KETTLEMAN HILLS FACILITY

**RE: CHEMICAL WASTE MANAGEMENT, INC. - KETTLEMAN HILLS FACILITY
DRAFT DIOXIN-LIKE PCB CONGENERS STUDY WORKPLAN
REVISION 1**

Subject: Draft Dioxin-Like Polychlorinated Biphenyl (PCB) Congeners Study Workplan Technical Review

FIG. 8-28 \ ANNUAL PCB IMPACTS \ FINE RECEPTOR GRID

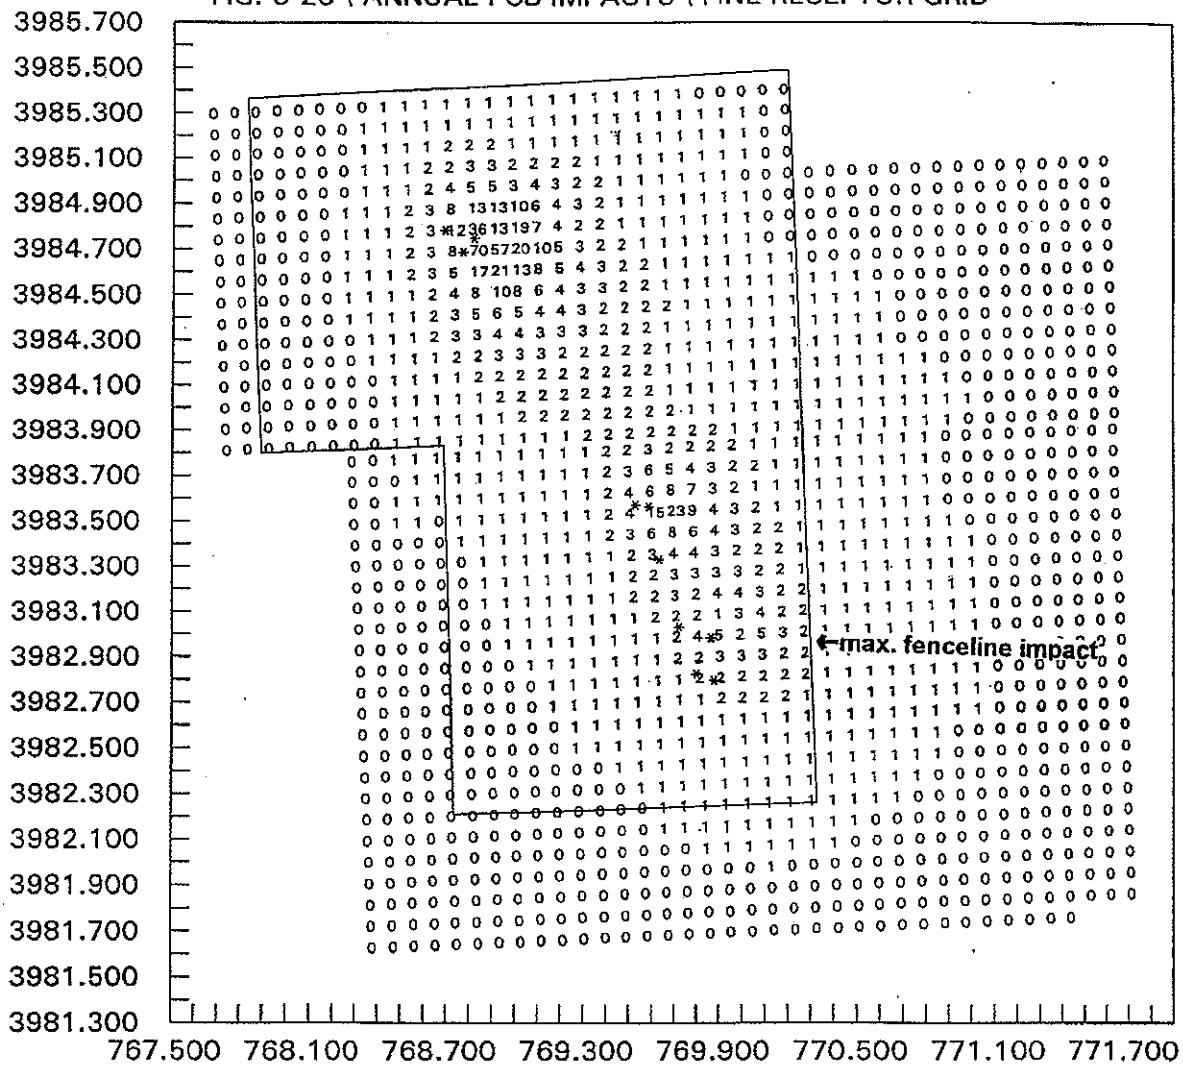
The investigational framework proposed by EPA for assessment of impacts from the current facility has attempted to incorporate several elements of this strategy. We believe several elements of the draft workplan have not adequately incorporated this overarching strategy. For instance, EPA anticipates that the enormous amount of air monitoring and meteorological data used in support of past ambient air and site-specific monitoring activities, can be effectively leveraged to support more precise site-specific

location analysis useful for the high-volume air sampling devices proposed for monitoring impacts from direct PCB disposal operations. The ability to consider landfill microclimate and air transport & dispersion characteristics unique to the PCB disposal surface offers the potential to provide critical information when assessing locations of maximal impact. Our review fully anticipated increased use of this level of data and analysis, and we believe significant efforts should be made to incorporate the facility's on-site meteorological data and the known patterns of air movement and transport to further inform the specific siting and location of the PCB congener sampling devices.

In studies such as these it is common to use air dispersion modeling data to help site air monitoring locations in areas anticipated to have the highest potential impacts from targeted source emissions. In this case, the targeted source is the B-18 landfill. Two previous air impact studies involved air dispersion modeling as a tool to predict impacts to ambient air at the fenceline and beyond from emissions at KHF. These were the 1) 1994 Topographical, Meteorological and Airborne Contaminant Characterization Study discussed in Section 2.6.1 of the Workplan, and 2) the project work to support the recently released Draft Subsequent Environmental Impact Report (SEIR) associated with the proposed expansion of the B-18 Landfill and future construction of a new hazardous waste landfill (B-20) at KHF. An exhaustive effort was made to obtain the raw modeling data from both of these projects to use as a tool to support the siting of the proposed monitoring locations for the PCB Congener Study. In the case of the 1994 Study, the raw modeling data was no longer available because the project was performed 14 years ago, and by a company that no longer exists. However, an isopleth figure from the 1994 Study (see attached) supports the basis that MSP and DMS-1 are located in the general area of maximum air impacts from KHF emissions. Though preparation of the Draft SEIR was performed more recently, it proved to be very difficult to obtain the modeling data used to predict air impacts as the modeler who performed the analysis has since joined a different firm and the company that performed the analysis could not obtain the data in time to prepare the Workplan. In the case of the Draft SEIR modeling, the data is really not comparable anyway to the types of emissions targeted in the PCB Congener Study.

KHF is located in the Kettleman Hills on the western edge of the San Joaquin Valley which, because of the topography, is classified as complex terrain. Complex terrain has its own unique micro scale meteorological conditions that result from winds channeling in valleys, and wind currents resulting from solar heating of hillsides and valleys. Though there are air dispersion models approved for use in complex terrain, localized property line impacts such as

those targeted in the PCB Congener Study Workplan, are subject to high levels of uncertainty when predicted using a statistical based model. For this reason, it is appropriate to use common sense, field observations, and site knowledge, to locate air monitors near specific emissions sources such as the B-18 landfill. This was the basis in logic for siting the proposed air monitoring locations. Another significant factor is also the availability of power needed for the high volume air samplers required to sample for trace level PCB congeners. While power availability cannot be a reason to avoid sampling in maximum impacts areas, it is certainly a factor that must be considered. However, power is available at DMS-1 and MSP, which as shown in the attached isopleth, are in the area of maximum impact from facility emissions.

To avoid any question that the proposed monitoring sites are not appropriately located to satisfy the objectives of this study, KHF has agreed to also place a temporary PUF air sampler near the administration building (see response to Specific Comment #2 and revised Workplan), as well as conduct air dispersion modeling of particulate depositional impacts from the B-18 Landfill. KHF and its consultant will work with USEPA-IX to obtain an approved modeling protocol, perform the necessary modeling, and provide a report to USEPA-IX summarizing the modeling results as they relate to the appropriateness to the siting of the proposed monitoring locations. Based on discussions with USEPA-IX, it is anticipated that this information will be used, along with field observations and site knowledge, to verify that the proposed sampling locations are acceptably located to meet the study objectives.
